## **ADDENDUM 1 – BID PACKAGE 2 PHASE B, C, D**

**DATE:** January 7, 2022 **M2 PROJECT #:** 201001

**PROJECT:** Greater Peoria Mass Transit

**OWNER:** GPMTD/ Citylink  
2105 N E Jefferson Ave, Peoria, IL

Project No: M1600050
- Sheet Title
- COMMUNICATIONS & SPECIAL SYSTEMS  
GENERAL NOTES,  
LEGEND, AND  
ABBREVIATIONS
- Sheet Number
- COM-000

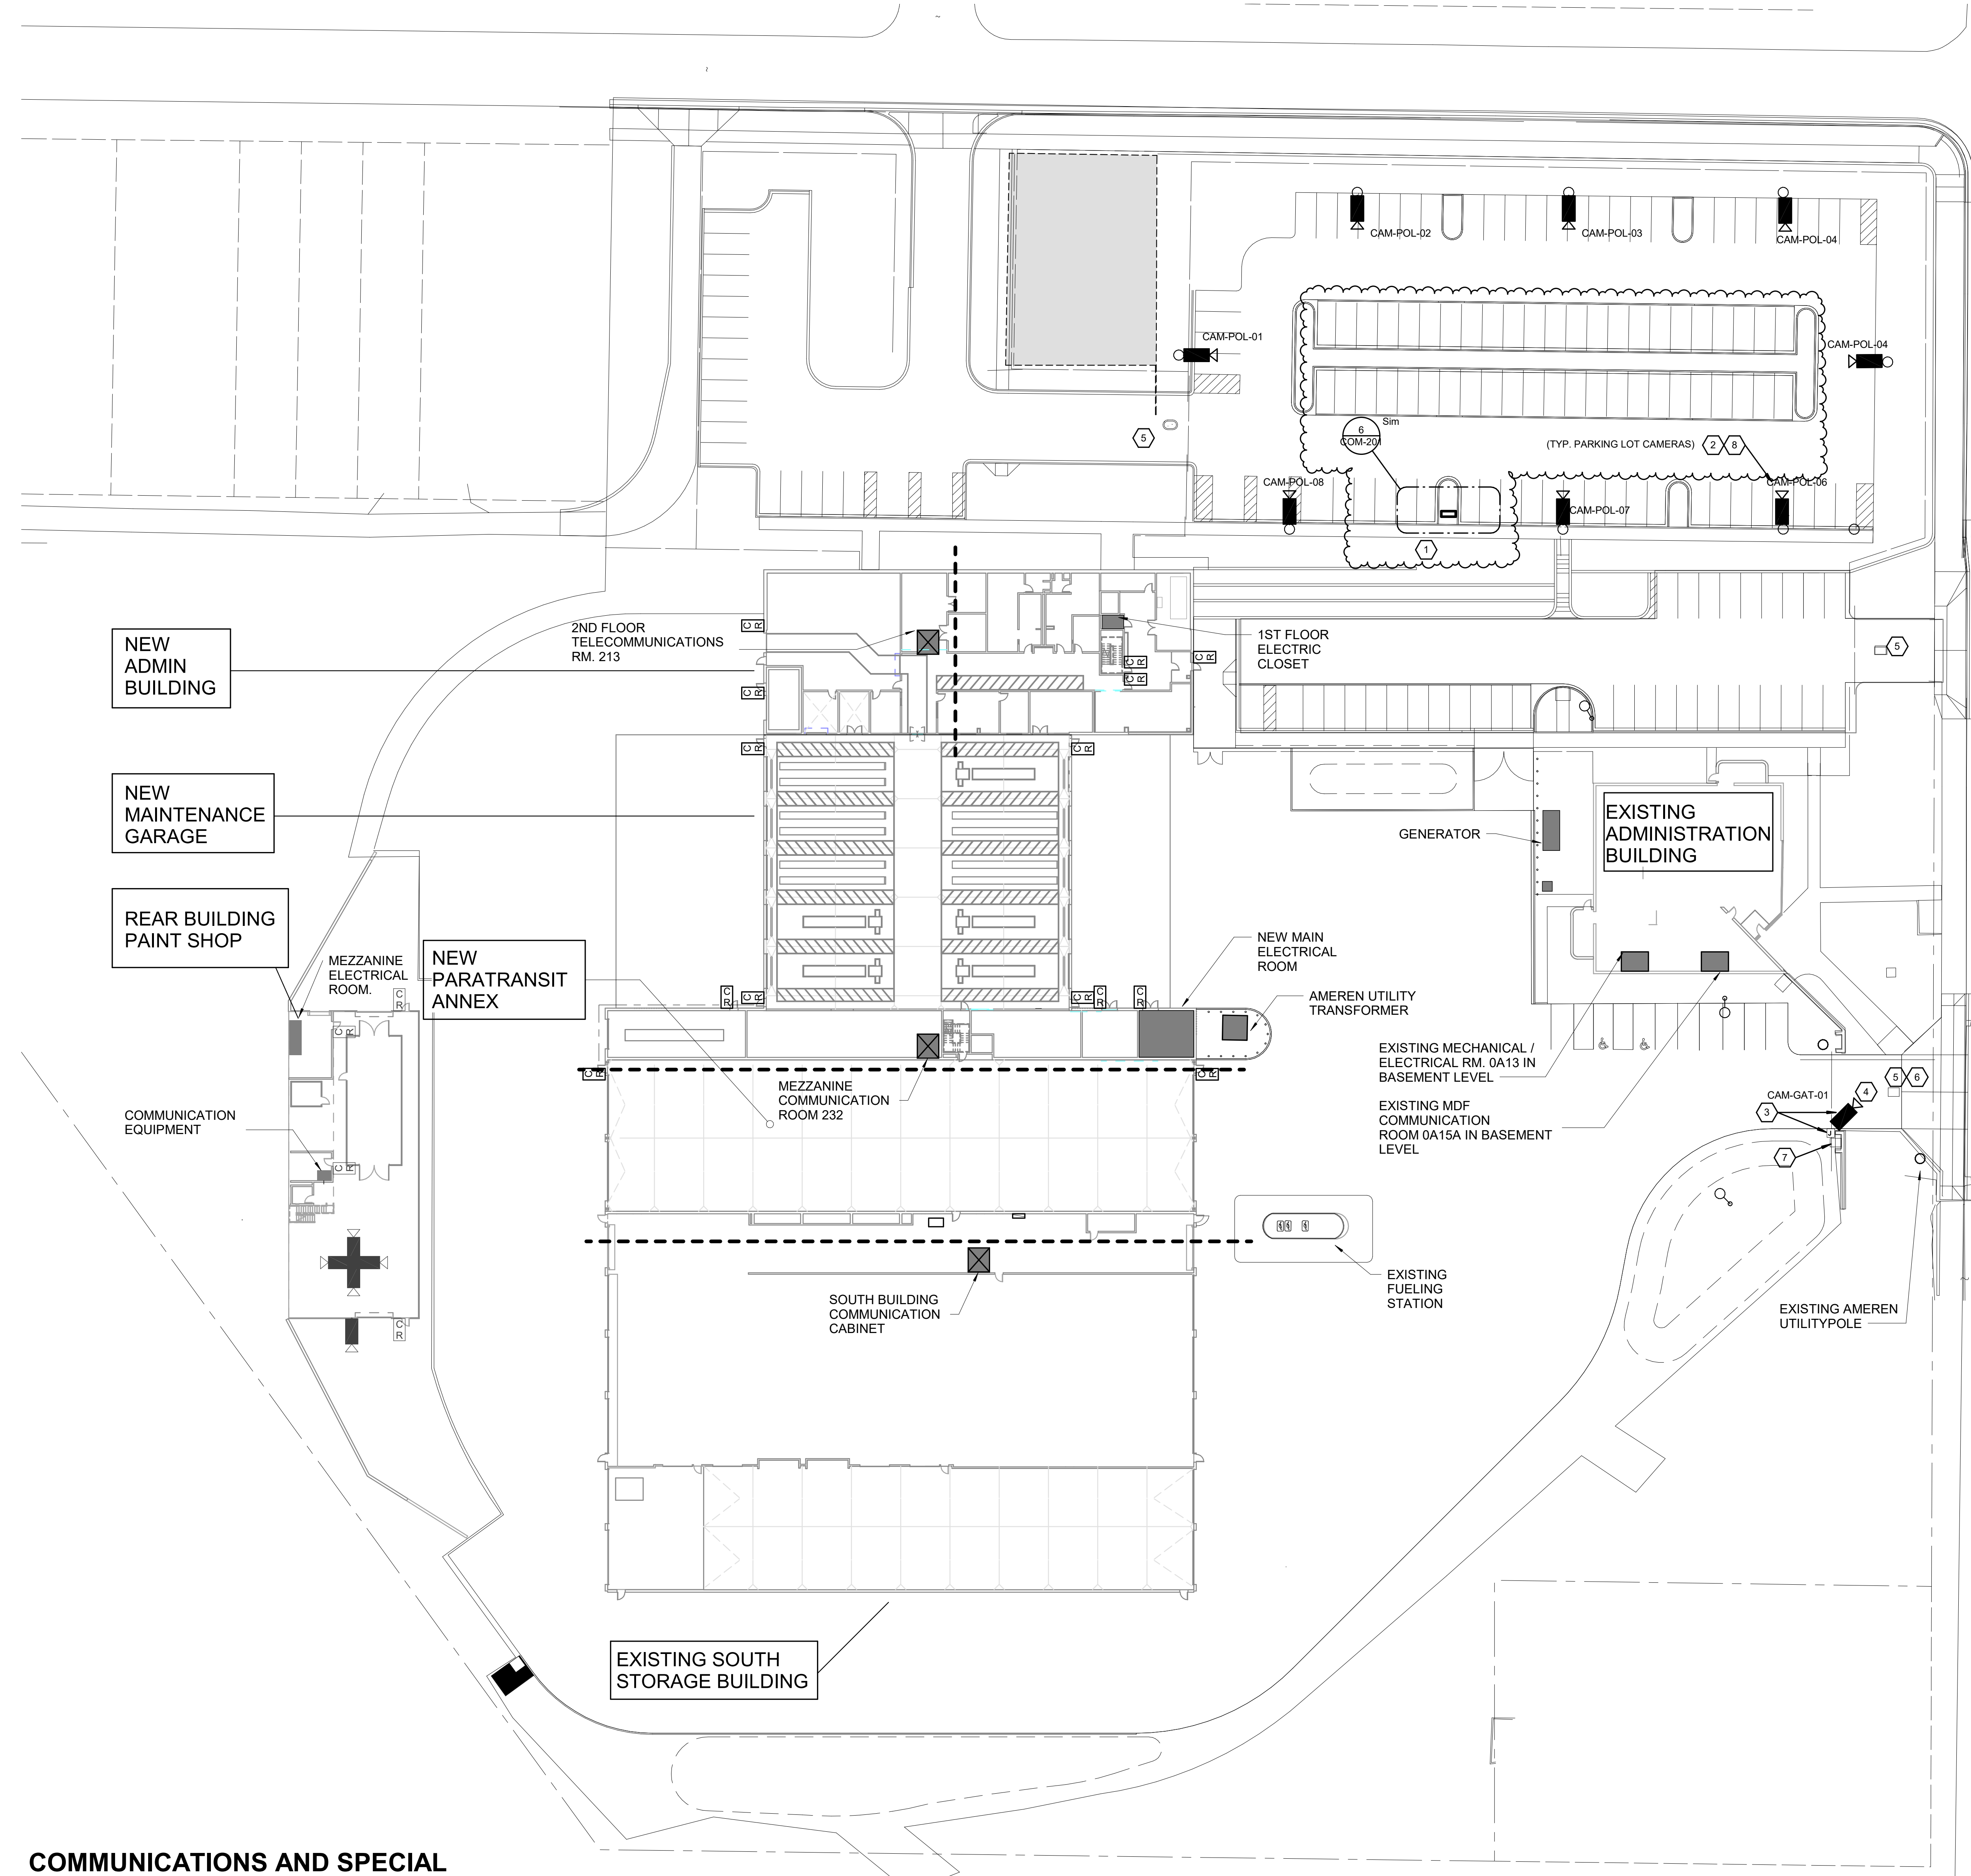
Under COMMUNICATIONS & SPECIAL SYSTEM SYMBOL LIST - Modified Wireless Access Point notes to reflect that APs will be provided by contractor (furnished and installed).

Added section TELECOMMUNICATIONS NETWORK ELECTROINCS NOTES – Contractor shall now provide network electronics (switches) as shown.

COMMUNICATIONS  
AND SPECIAL  
SYSTEMS SITE PLAN

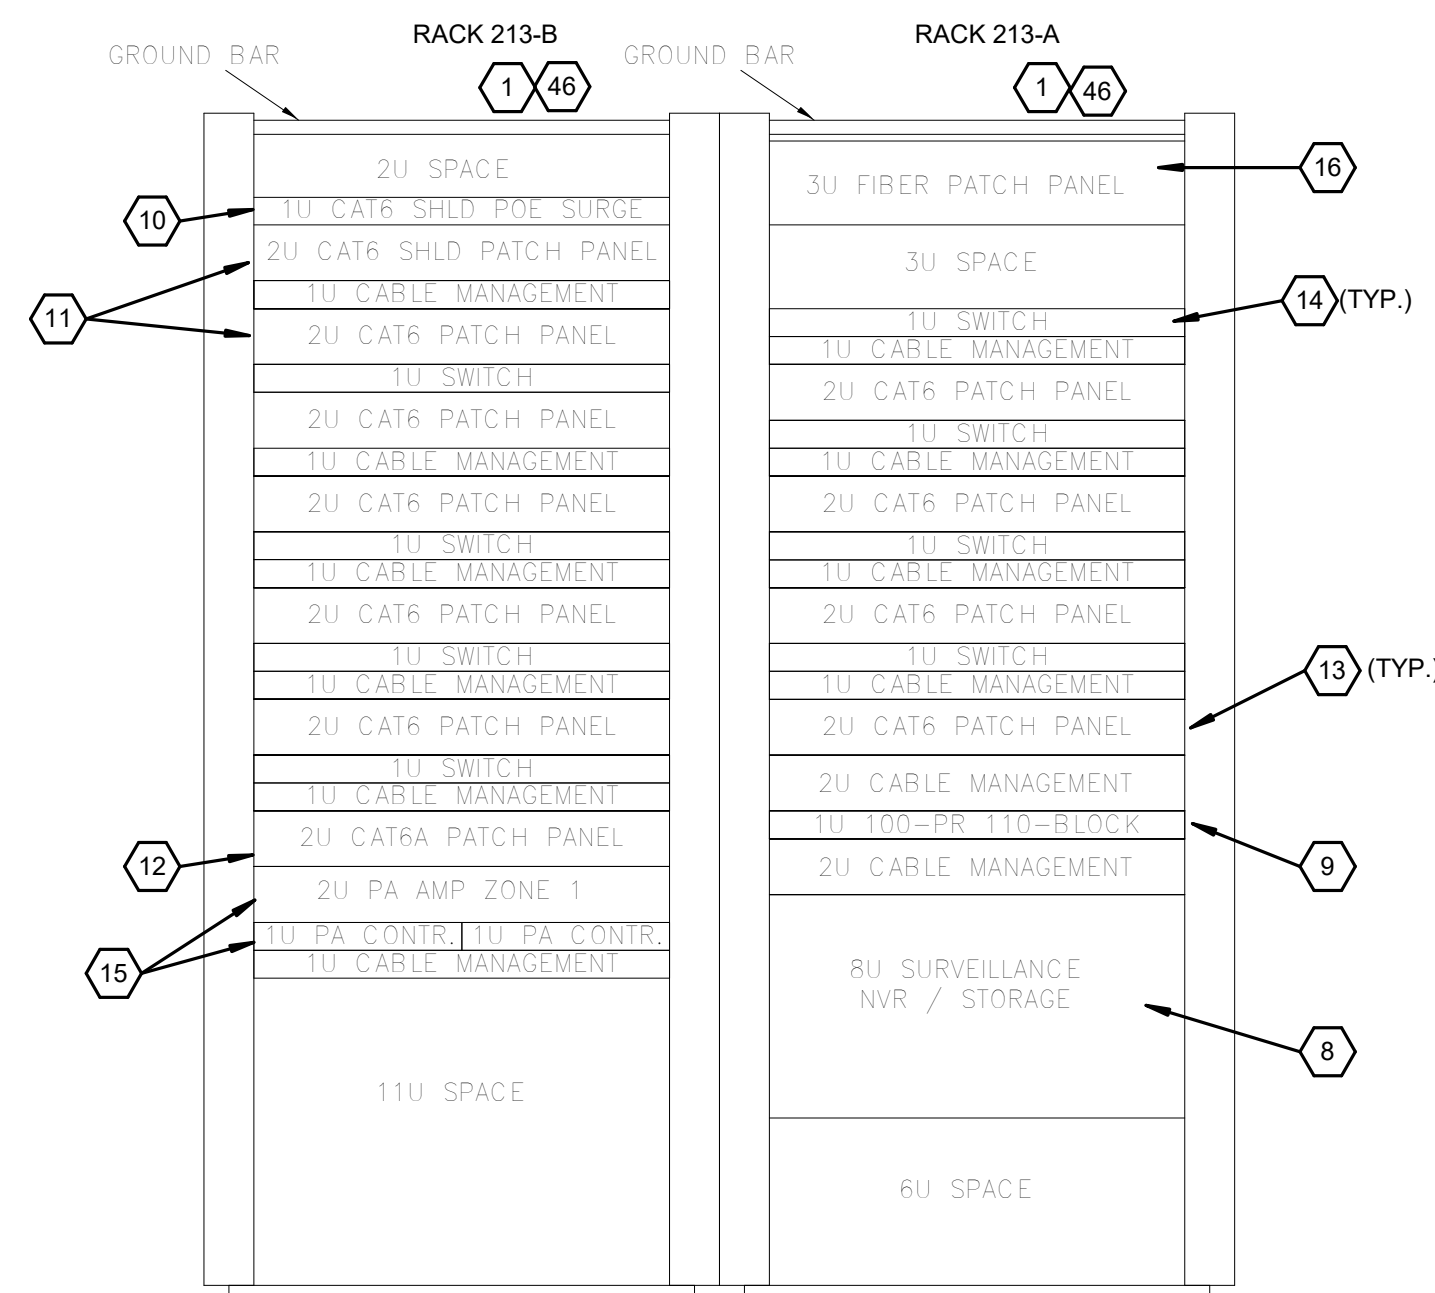
Modified location of the surveillance cabinet.

Added keynote and keynote reference 8 for additional information about light-pole mounted cameras.

Keynote 2 updated to reflect that there will not be a need for dedicated camera poles.
